Joseph M. Farley Nuclear Plant
Final Supplemental Response to NRC Generic Letter 2004-02

**Joseph M. Farley Nuclear Plant
Final Supplemental Response to NRC Generic Letter 2004-02**

Farley Nuclear Plant Final Supplemental Response to GL 2004-02

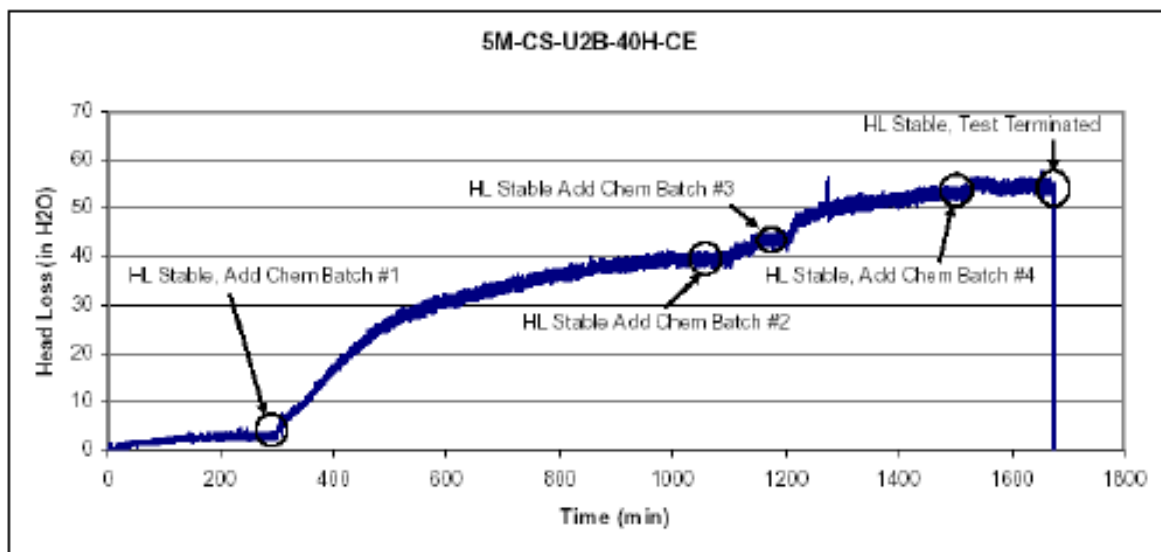
- 27) 17.d.i Data Analysis: Licensees should provide a copy of the pressure drop curve(s) as a function of time for the testing of record.

SNC Response 17.d.i:
